Better Housing by Design Project: Potential Amendments to the Revised Proposed Draft

Better Housing by Design Project: Potential Amendments to the Revised Proposed Draft

Technical Amendments

6 – In the Alhabet Historic District, change the application of the proposed RM3 and RM4 zones to better reflect historic development patterns

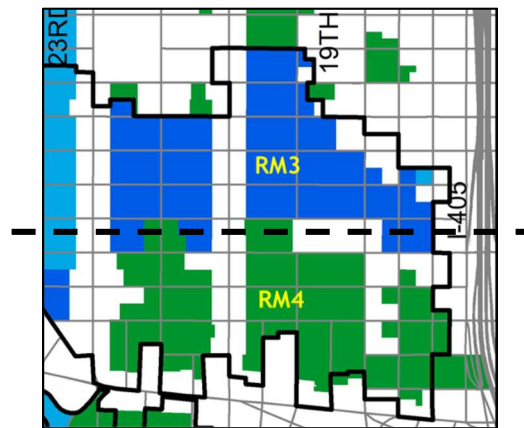
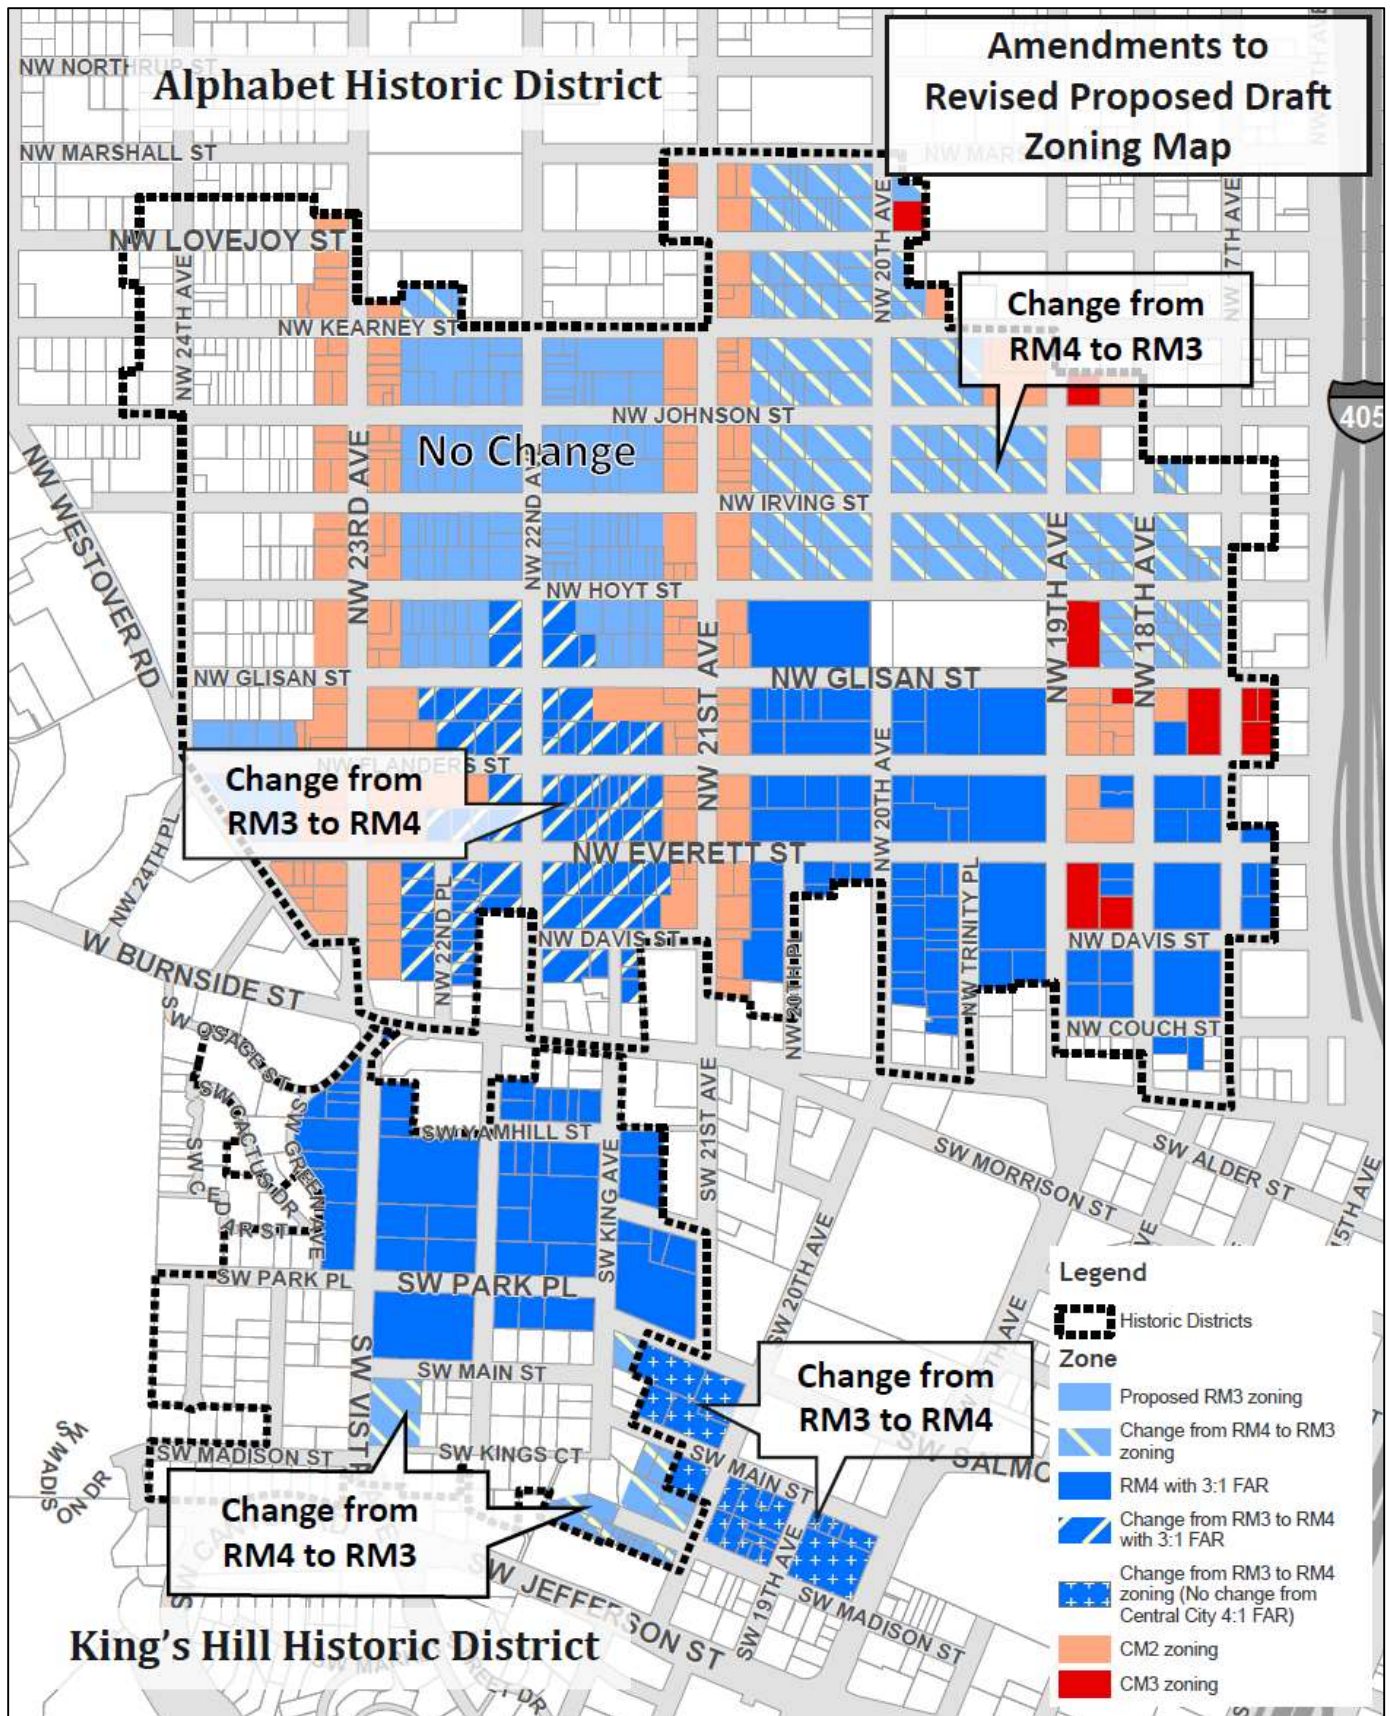
Amendment Summary. In the Alhabet Historic District, apply the larger-scale RM4 zone to current RH areas south of NW Glisan/Hoyt, and apply the smaller-scale RM3 zone to areas north of this. This would be a change from the current zoning pattern, where there is an east-west division between the larger- and smaller-scale RH zones. There are two components to this change:

- (1) **Apply RM4 zoning to the area between NW 21st and NW 23rd, from Burnside to Glisan/Hoyt,** instead of the proposed RM3 zoning. This would increase the base FAR in this area from the current 2:1 FAR to a base FAR of 3:1 and a bonus FAR of 4.5 to 1, which would allow for a range of development similar to the scale of larger historic buildings in this area.
- (2) **Apply RM3 zoning to the area east of NW 21st north of Glisan/Hoyt,** instead of the proposed RM4 zoning. This would decrease the base FAR in this area to 2:1 (bonus FAR of 3:1).

Rationale: These mapping changes will be more responsive to the scale of historic buildings in the district, where larger buildings are concentrated between Burnside and NW Glisan/Hoyt. These changes respond to Comprehensive Plan Policy 4.49, which calls for base zoning that takes into account the character of historic districts.

7 – In and around the King’s Hill Historic District, change the application of the RM3 and RM4 zones to better reflect existing development patterns

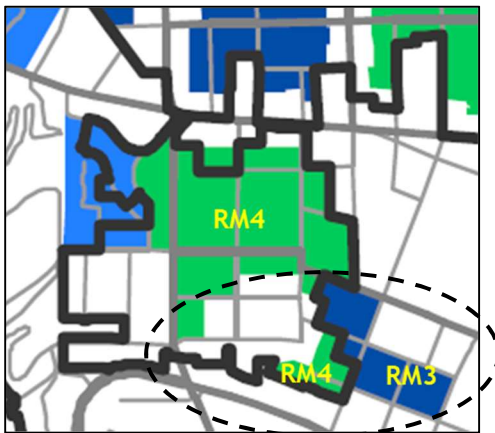
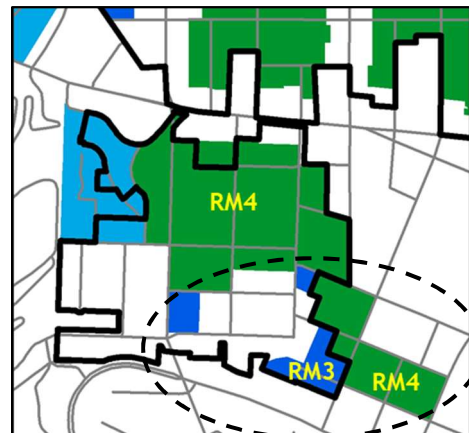
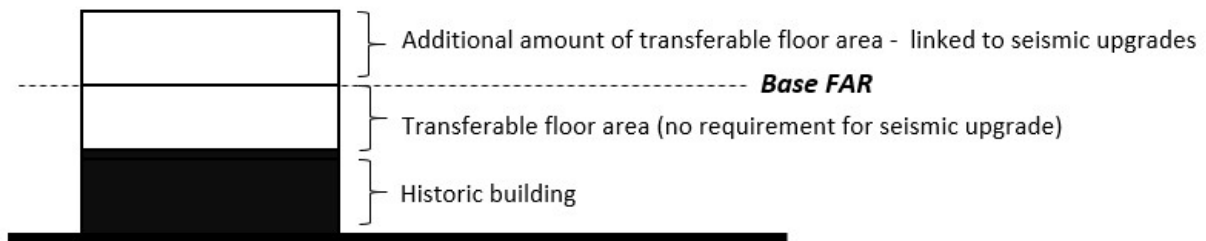
Amendment Summary: In the King’s Hill Historic District, apply the RM3 zone to properties with small historic structures at the edges of the historic district, and apply the larger-scale RM4 zone to currently RH zoned areas outside the historic district to the east. This will be a change from the current zoning pattern, where all of the current RH zoning in the historic district has a base FAR of 4:1 and was proposed for RM4 zoning. There are two components to this change:

- (1) **Apply the smaller scale RM3 zoning to properties with small historic structures at the southern edges of the historic district**, instead of the proposed RM4 zoning. This area has mostly smaller lots with small historic buildings (2-3 stories) and is adjacent to single-dwelling R5 zoning. This would decrease the base FAR in this area to 2:1 (bonus FAR of 3:1).

- (2) **Apply the larger-scale RM4 zoning to a three-block area outside the historic district to the east**, instead of the proposed RM3 zoning. This area is in the Central City Plan District, which provides a base FAR of 4:1. RM4 zoning would more closely correspond to this and other development standards that apply in this area. The primary change is that the block west of SW 20th between Salmon and Main streets would become eligible for the transit station area allowance for 100-foot building height (this block includes large existing buildings over 80-feet tall which exceed the current height limit of 65 feet). The other two blocks in this area are already provided with a Central City Plan District height allowance of 100 feet.

Rationale: Applying RM3 zoning at the southern edges of the King’s Hill Historic District will be more responsive to the scale of historic buildings in this area of the district, while applying RM4 zoning to the east of the district will more accurately reflect Central City development allowances that apply in this area, as well as better reflect the scale of existing development.
